STAFF REPORT
WEST ALLIS PLAN COMMISSION
Wednesday, May 23, 2018
6:00 PM

3. **Site, Landscaping and Architectural Plans for Mitchell Elementary School, an existing elementary school, located at 10125 W. Montana Ave., submitted by Thomas Williamson, of Ruekert Mielke, Inc. and Tim Williamson of the West Allis West Milwaukee School District (Tax Key No. 519-0044-000).**

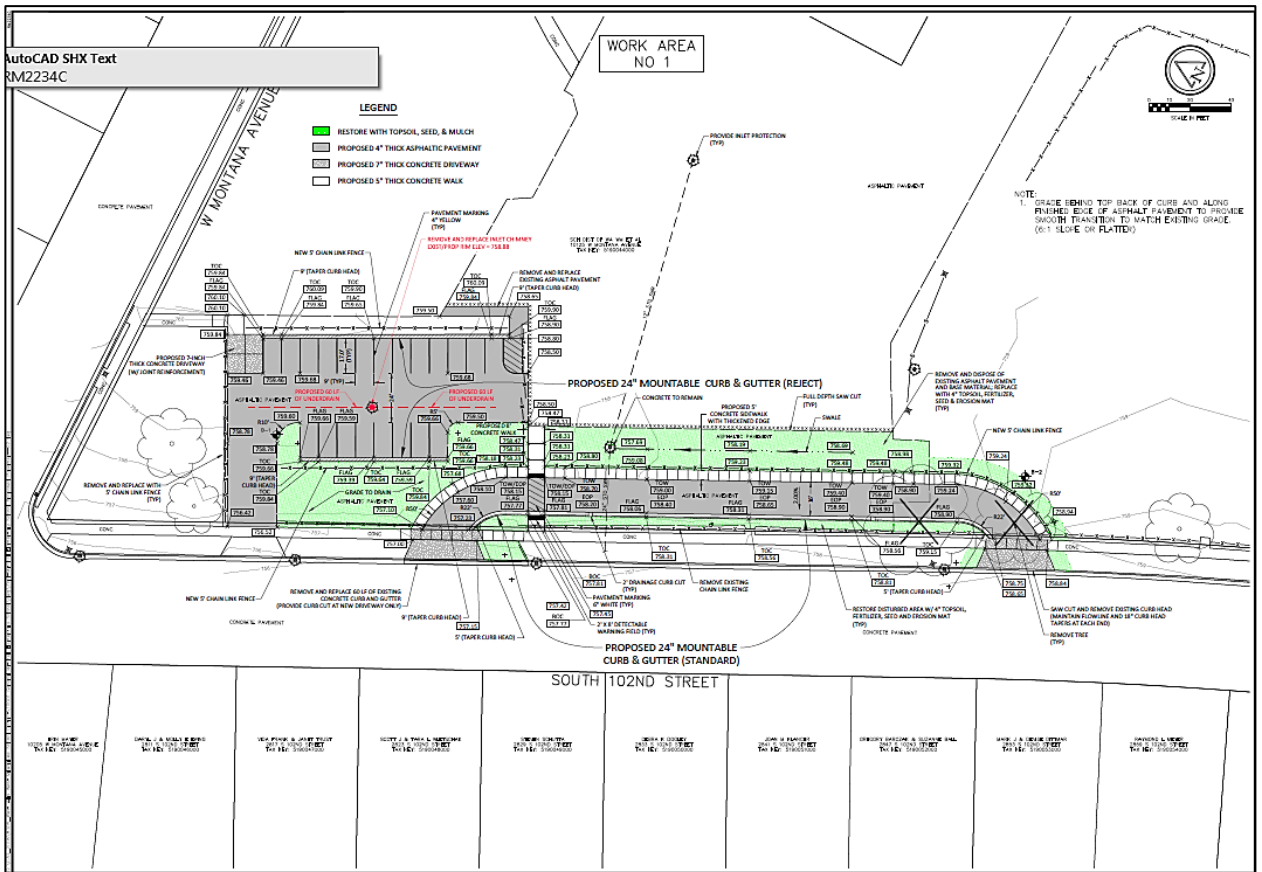
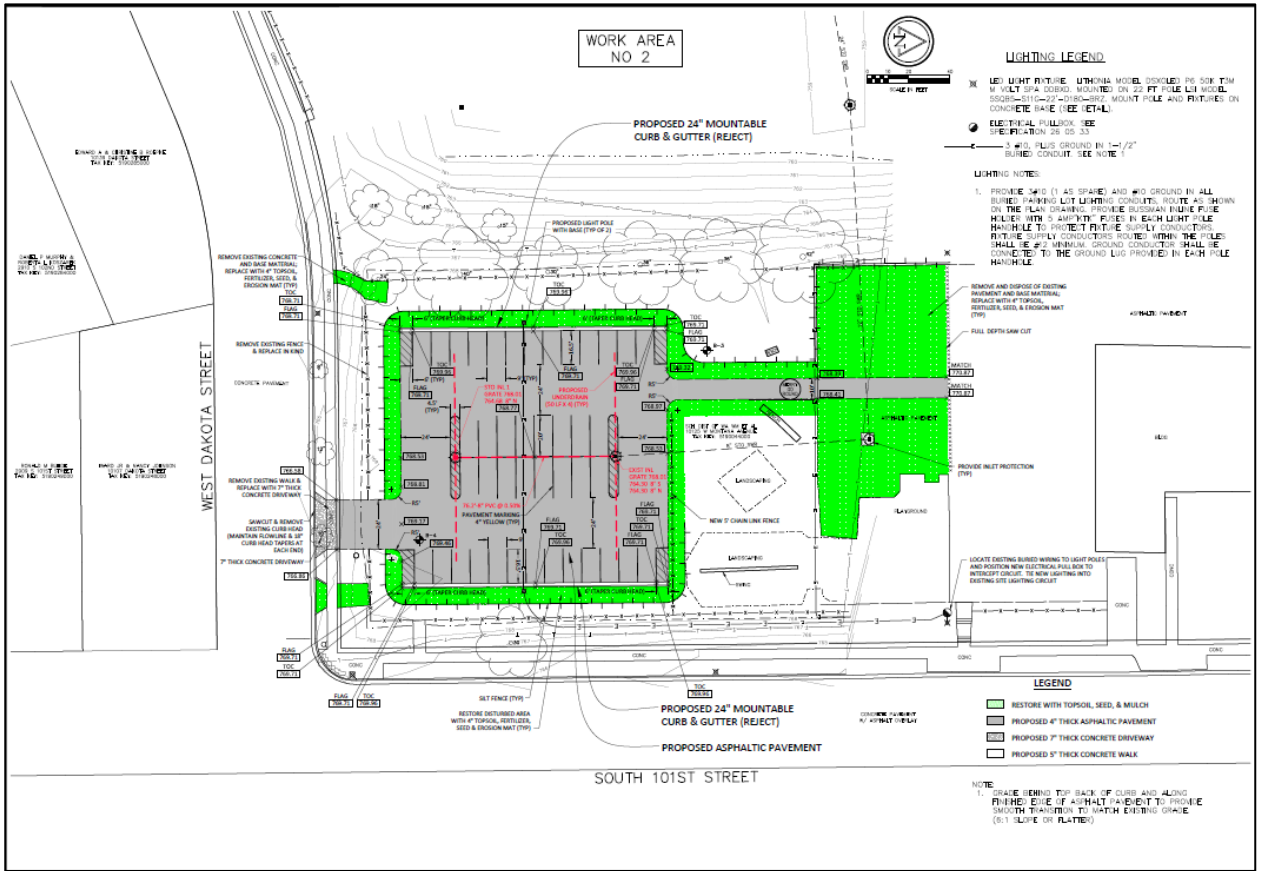
Staff comment - The application indicates that there isn't certainty yet as to which option would be implemented first. Cost estimates range between \$250,000 to 300,000, but budget authority has not been obtained from the School District. From the City Planning perspective staff is recommending that this item be held until more information on phasing, cost and budget authority is provided.

From the planning perspective staff questions the actual need for a 42 stall parking lot in the SE portion of the campus vs. maintaining all or at least more of the existing greenspace which offers recreational opportunity for the school children and the neighborhood.

SE Parking lot – The general perspective on the elimination of a playfield for parking lot is in question.

1. Not understanding the full need for this additional parking lot.
2. How many staff/employee are there at Mitchell, and of that number how many drive?
3. Please explain the history behind the need for more parking.
4. Have any other alternatives have been considered up to this point?

5. Tree plantings within the new grass area between playground drop off lane.

6. Lighting photometric plan will be needed.

7. Compliance with the City stormwater management ordinance including necessary WDNR and MMSD water quality and quantity measures.

8. Consideration of fencing upgrades from 5-ft chain link to a variety more decorative.
9. A refuse enclosure is recommended for the dumpsters on site (lower) west playground.
